Office Action Summary

10/518,596

DEMUTH ET AL.

DETAILED ACTION***Drawings***

FIG.1

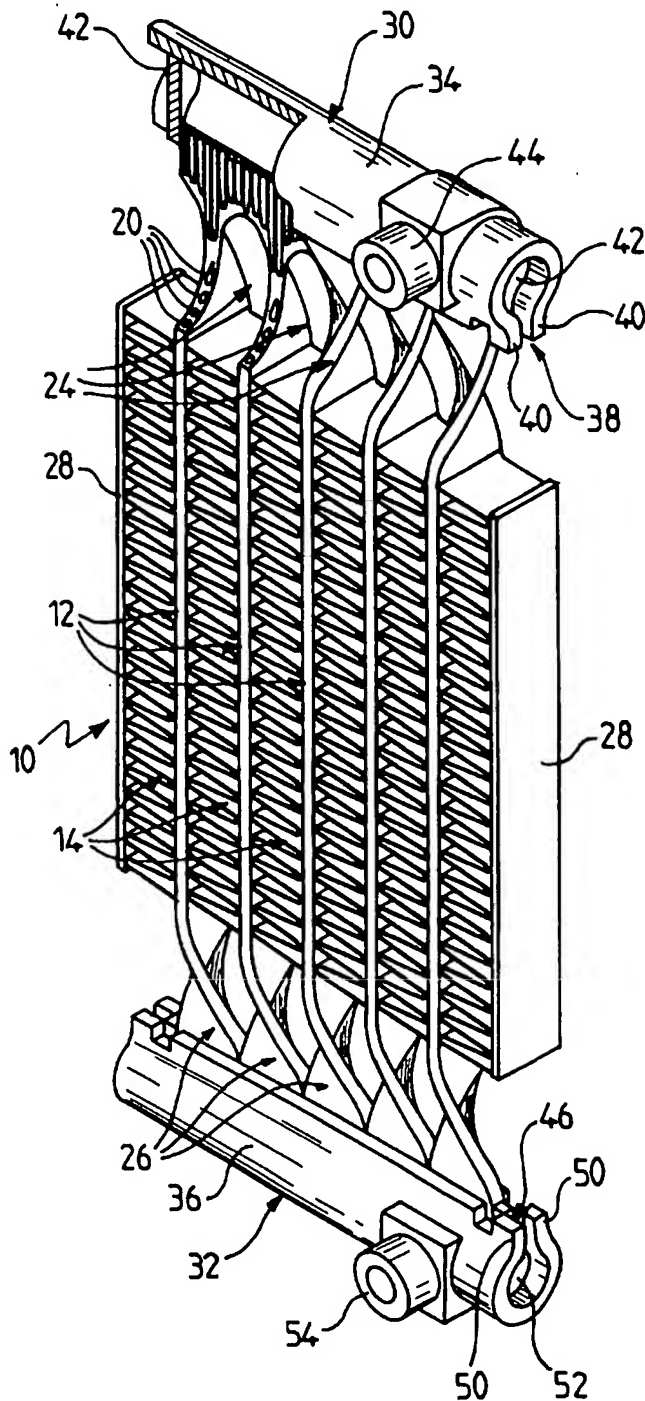
In regard to claim 6, Carlos teaches (Figure 1) that the number of first (24) and second flow connection sections (26) is equal to the number of tube sections (12).

In regard to claim 21, Carlos teaches (Figure 1) that the internal cross section of the receiving devices (24) substantially correspond to the external cross section of the through-flow device (12).

In regard to claim 24, Carlos teaches that the pluralities of through-flow devices (12; 56) are arranged substantially parallel to one another (Figures 1, 4; translated page 7, lines 12-14).

FIG.2

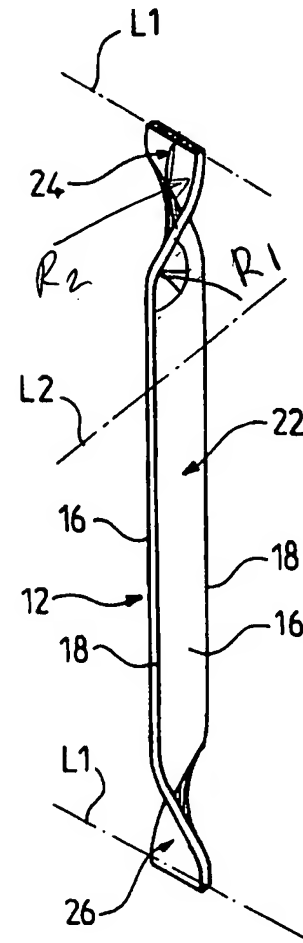
In regard to claims 12, Carlos teaches that the two transition sections (24, 26) are twisted in opposite twisting directions (Figure 2).

In regard to claim 22, Carlos teaches (Figure 2) that the receiving devices are substantially rectangular in form (24), and the longer side of these receiving devices is arranged at a predetermined angle with respect to the longitudinal direction of the distribution/collection device (30, 32; Figure 2).

FIG.3

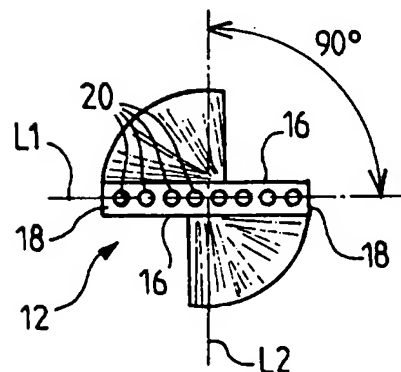
In regard to claim 23, Carlos teaches that the magnitude of the angle of the through-flow device is between 0° and 90° (Figures 2, 3).
